Our ref: NMS-NRC-04-009  
Your Ref: NRC LTR Aug 26, 2004

Subject: CERTIFICATE OF COMPLIANCE NO. 9297 FOR THE MODEL NO.  
TRAVELLER PACKAGE, RESPONSE TO NRC REQUEST FOR  
ADDITIONAL INFORMATION (RAI)

Request for Additional Information  
Model No. Traveller  
Docket No. 71-9297

**Figure 2-1A Sample of Clamshell Accelerations Measured During Road Test (May 11, 2004)**

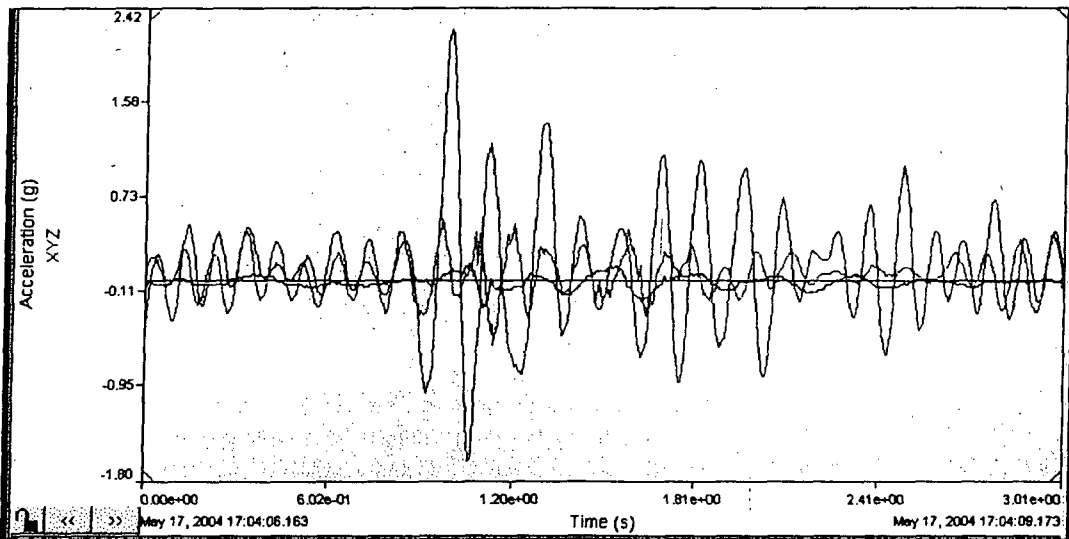
- 2-3 Revise Section 2.6.5 to include an evaluation of vibration frequencies of the Clamshell-shock mount system to ensure that no resonant vibration conditions could occur yet result in damage to the Clamshell and its contents during normal conditions of transport.

The following text and figure have been added to Section 2.6.5:

There are several natural frequencies of the shock mount system depending on direction of movement. The dominant frequency is for vertical movement. This frequency is between 5.9 and 6.7 Hz (for Traveller XL) depending on the weight of the fuel assembly being transported. The fore and aft pitch frequency is slightly higher (6.9-7.9 Hz) but has a lower amplitude. Road tests have been performed with the suspension system to measure amplitudes during shipping. Figure 2-1A is characteristic of the results seen. When the truck travels over a bump, the clamshell initially sees relatively large accelerations (2-3 g's) but this oscillation quickly damps out to accelerations less than 1 g. This 300 mi trip involved approximately five and a half hours on the road with  $1.4 \times 10^5$  total cycles.

**Figure 2-1B Impact Limiter "Pillow" Assembly**

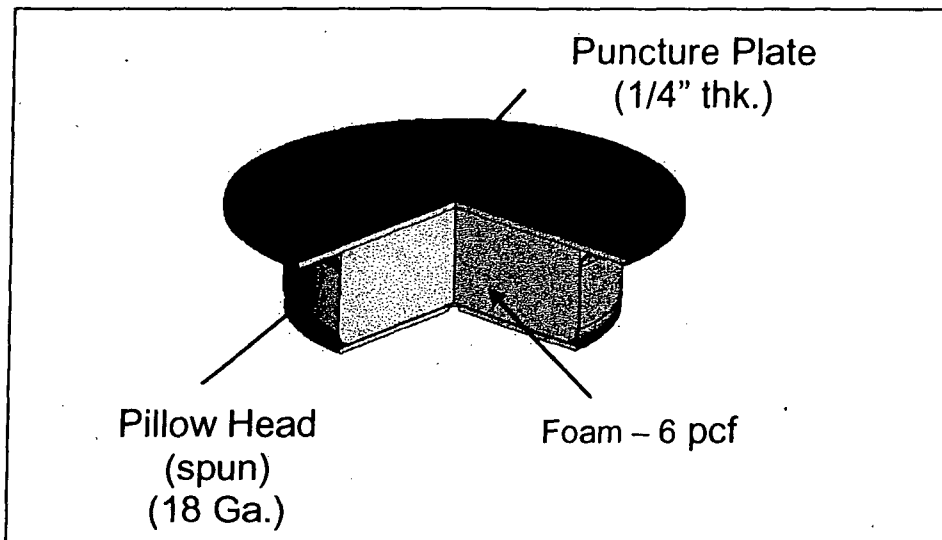
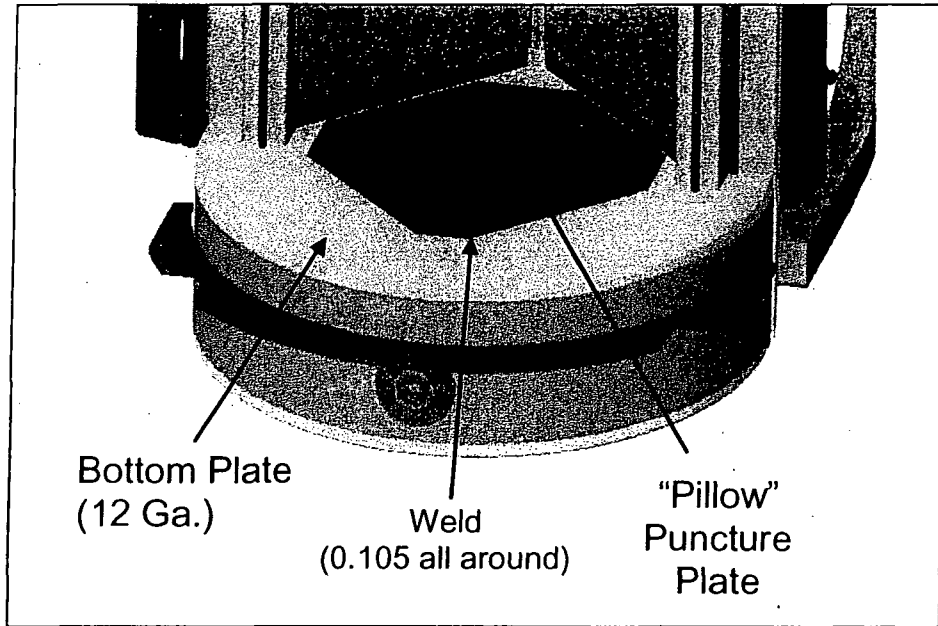
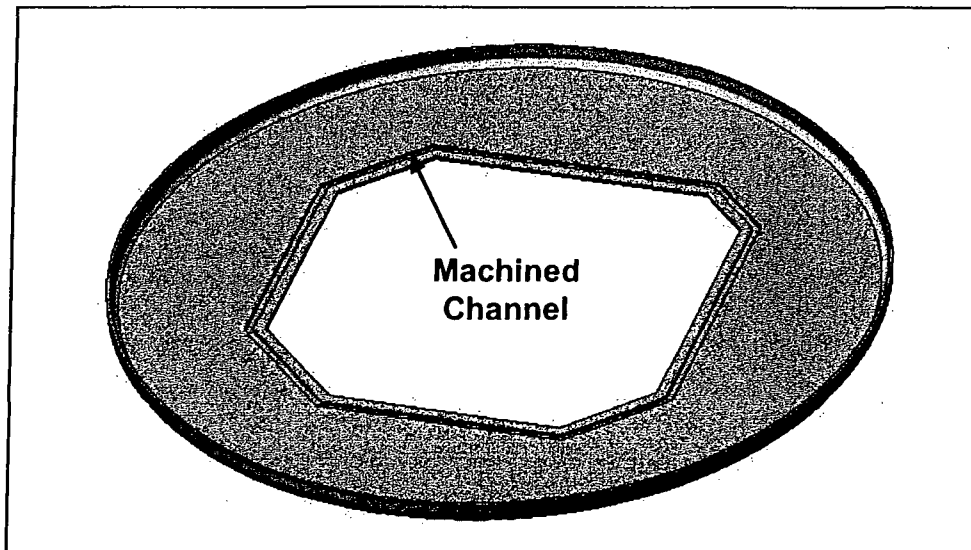
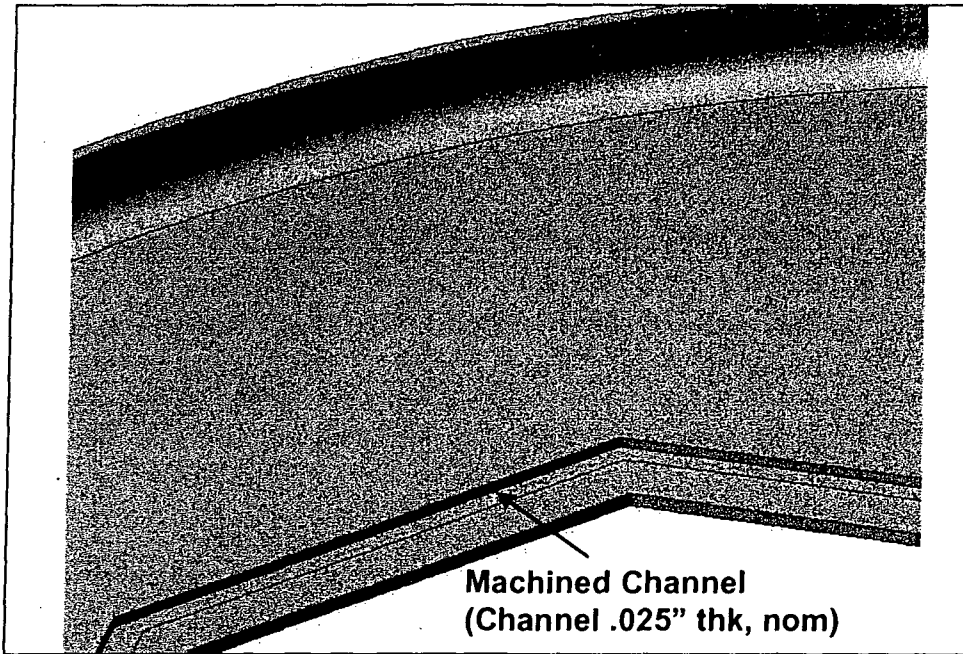
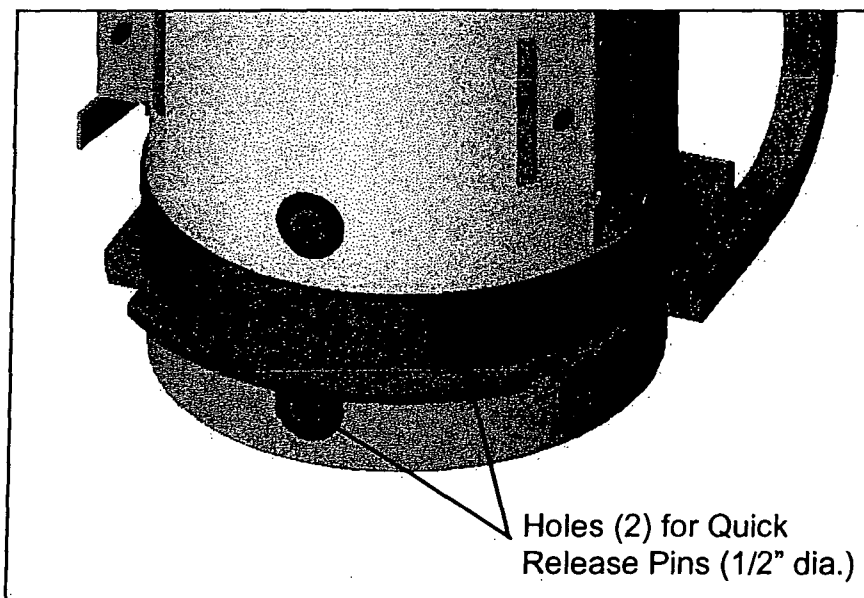
2-5 Provide drawing details for the design changes introduced to the Certification Test Unit drop tests to improve performance of the package, including welding of the impact limiter pillow to the Outerpack liner plate and modification of the quick release pin. Changes to the packaging features that are important to safety should properly be presented in design drawings (Table 2-5, Page 2-22).

The following text and figures have been added to Table 2-5:

The figure below (Figure 2-1B) shows the impact limiter, or Pillow, assembly (shown without insulation). This assembly is shown installed in the Traveller package bottom (the configurations are the same for STD and XL packages) in Figure 2-1C. The weld between the bottom plate (yellow) and the puncture plate (red) is also shown. During testing this weld failed as expected, however, it did not completely allow the components to separate. This design change weakens the bottom plate by reducing its thickness to a nominal 0.025" thickness, as shown in Figures 2-1D and 2-1E. A .25 inch wide channel was added to weaken the part.

The CTU design included a pinned connection (2 quick release pins – 0.5" diameter) between Outerpack halves at the bottom end of the package. Quick release pins were designed to help prevent the halves from warping and opening a gap locally during fire testing. Figure 2-1F shows the location of the quick release pins. During drop testing, the pins failed, therefore, they could not be used in the fire testing.

**Figure 2-117A Accelerometer Locations on Prototype Drop Test**

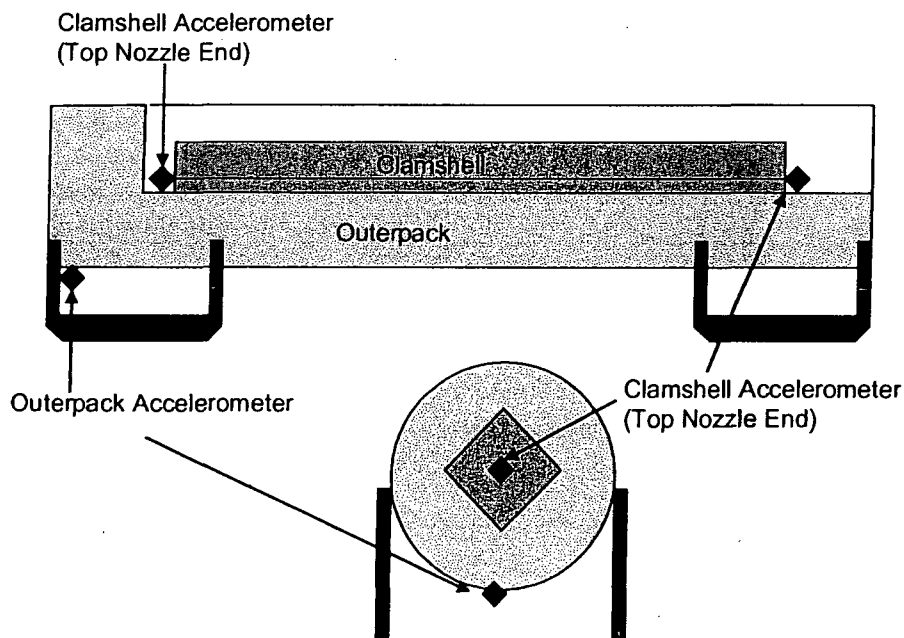
- 2-18 Provide sketches depicting the accelerometer installation plan for the drop tests. The application should include accelerometer locations on the test articles to evaluate correlation between the measured and predicted results.

The following text and Figure 2-117A have been added to Section 2.12.4:

The locations of these accelerometers are shown in Figure 2-117A.

Figure 2-108 Stress-Strain Characteristics of Aluminum in Clamshell

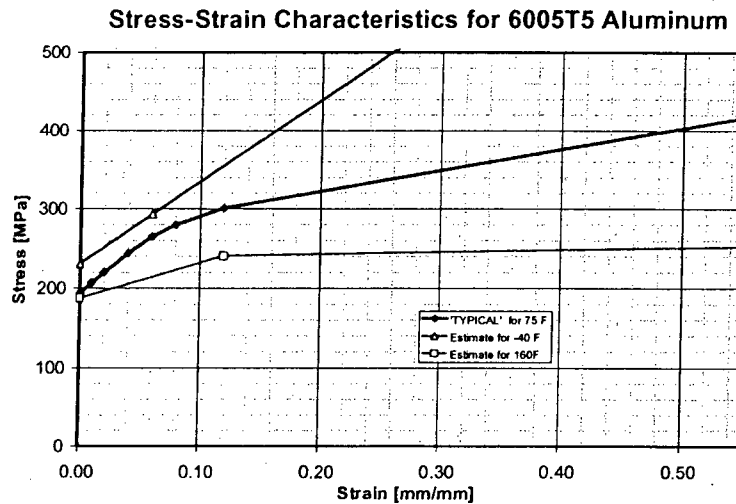
- 2-21 Verify the temperature-dependence stress-strain curve plots, Figure 2-108, for the Clamshell aluminum at 160° F and -40° F. The stress-strain curves at the two temperatures appear to have been mislabeled.

The following figure, Figure 2-108 has been replaced:

**Figure 2-95 Impact Limiter in Prototype Unit Model**

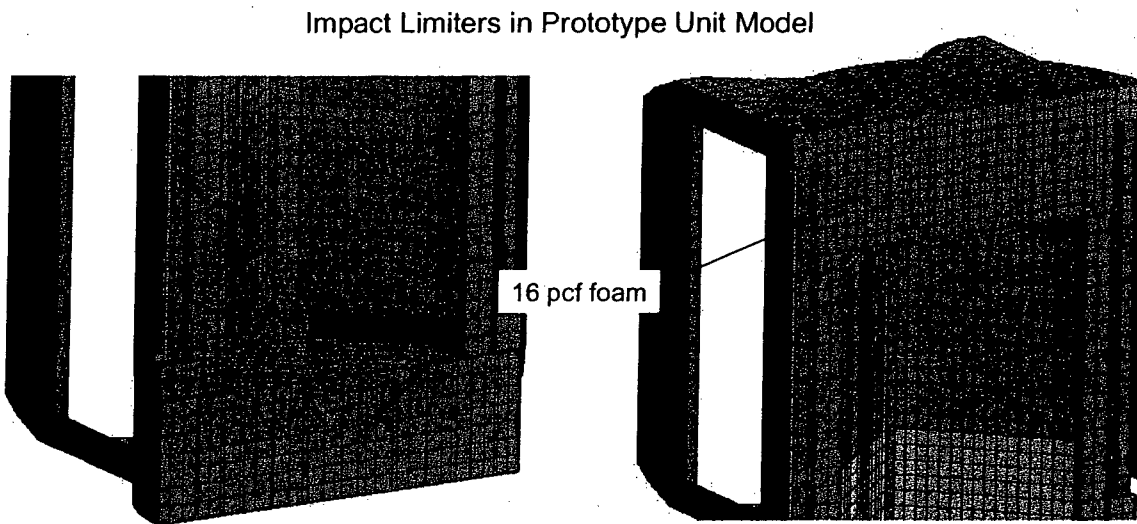
- 2-25 Provide a discussion clarifying the apparent discrepancy between the statement provided on page 2-148, "[t]he prototype packages employed 11 pcf foam along the axial section of the package and 16 pcf foam in the endcaps," and the information provided in Figures 2-95 and 2-112 which indicate that the end cap for the Prototype Test Unit was filled with the 11 pcf, rather than the 16 pcf, foam.

The following figure, Figure 2-95, has been replaced:

**Figure 2-91 Predicted and Measured Y Accelerations**

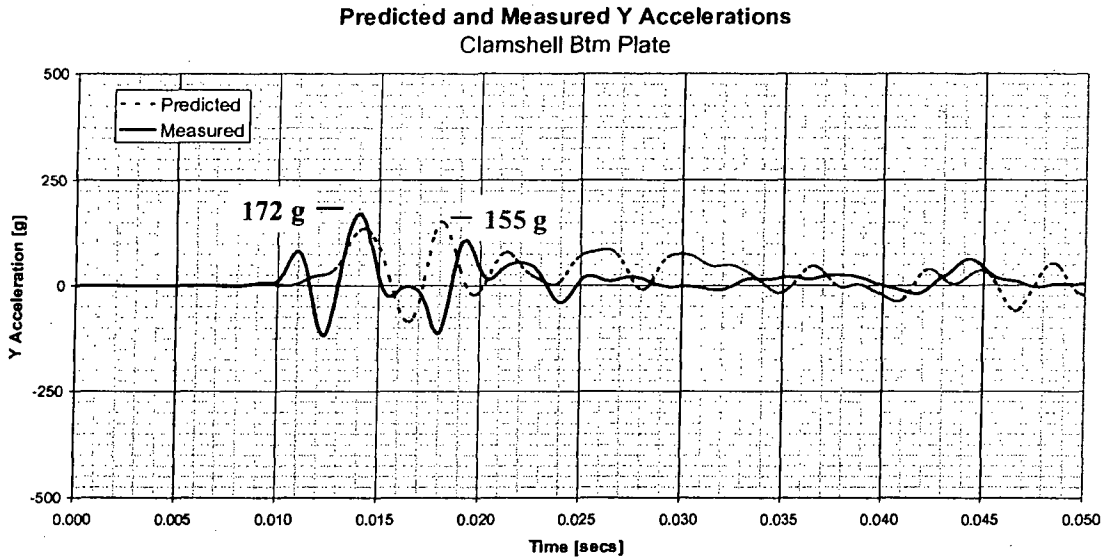
- 2-27 Provide a discussion explaining the apparent discrepancy between the measured vertical decelerations of 191 g in Table 2-30 and 205 g in Figure 2-91.

The following figure, Figure 2-91, has been replaced:

**Figure 2-129 Drop Orientation for QTU Test Series 1**

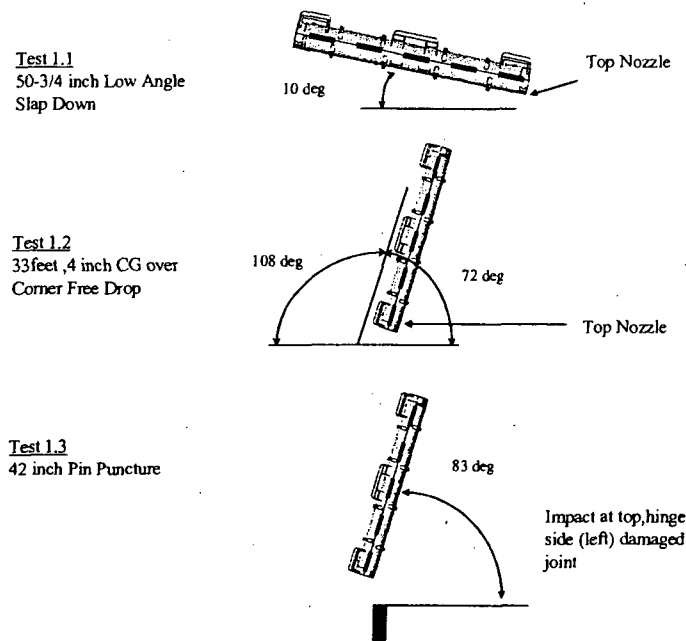
- 2-28 Provide a discussion clarifying the drop angle/orientation depictions of Test 1.2 and Test 1.3 in Figure 2-129 for the respective CG-Over-Corner and pin puncture tests. It is not clear how the drop angle of 108° was defined for Test 1.2. The puncture drop of Test 1.3 does not appear to have the package hinge side of the Outerpack land on the puncture pin as described in the text.

The following text has been added to Section 2.12.4.2.1 and Figure 2-129 has been replaced:

A pitch angle of 72 degrees was measured along the outerpack surface for Test 1.2. The angle of 108 degrees should be located as shown in Figure 2-129. The reference to "hinge side" in Test 1.3 indicates the package side that pivots, rather than the actual hinge. The impact point of Test 1.3 (Figure 2-132) was on the top nozzle end and on the pivot (left) side of the package.

**Figure 3-27A Orientation of CTU for Thermal Test**

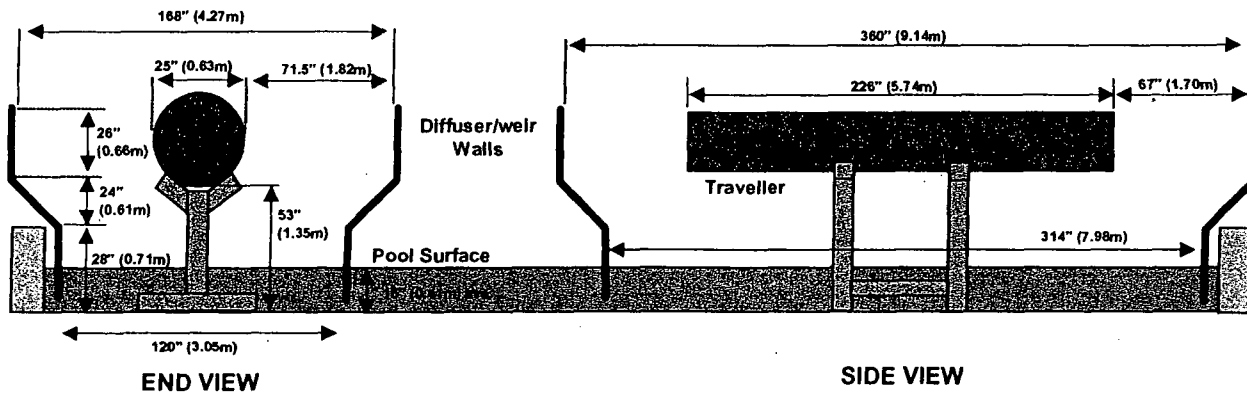
- 3-1 Revise the SAR to specify the orientation of the certified test unit (CTU) with regard to the fire test pool. Specifically, state the distance the bottom of the package was positioned above the fire pool surface and the distance the pool extended beyond the ends of the package.

The following text and figure have been added to Section 3.6.4:

Figure 3-27A shows the orientation of the Certification Test Unit (CTU) for the thermal test. The bottom of the package was positioned approximately 1 meter from the top of the fire pool surface. The distance of the outer facility walls beyond the edge of the package were 67" at the ends and 71.5" at the sides.

Figure 3-27C Approach to Suppress Pool Fire at End of Test

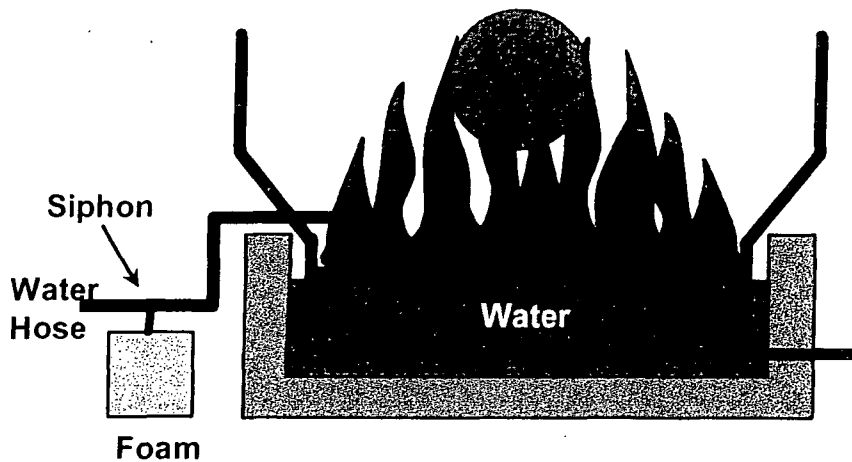
- 3-10 Revise the SAR to clearly state that the package after the fire test was allowed to burn until it naturally extinguished. Also, include a discussion why none of the means used to extinguish the pool fire had any adverse impact on allowing the package to burn as long as it naturally could.

The following text and Figures 3-27B and 3-27C have been added to Section 3.6.4:

The fire test facility was originally designed to terminate the fire test by shutting off fuel flow and allowing the fuel at the surface of the pool to burn off. Testing revealed that, in some circumstances, excess fuel could buildup on the pool surface causing the fire to continue burning for five minutes or longer. As a result, a simple fire suppression system was added to the facility. A water hose was connected to a nearby fire hydrant, Figure 3-27B. This hose utilized a suction line to siphon standard fire suppressant foam into the line, Figure 3-27C. The hose discharged into a single pipe that fed into the pool a few inches above the water level. When activated, the system would inject foam horizontally onto the surface of the pool, well below the test article. When used in combination with the fuel shutoff valves, the pool fire was extinguished within 60 seconds. This system did not cool the test article when in use and the package was allowed to naturally extinguish itself after the test. This was demonstrated by the CTU burn test, where the polyurethane at the Outerpack vent ports continued to burn many minutes after the fire suppressant was used on the pool surface.
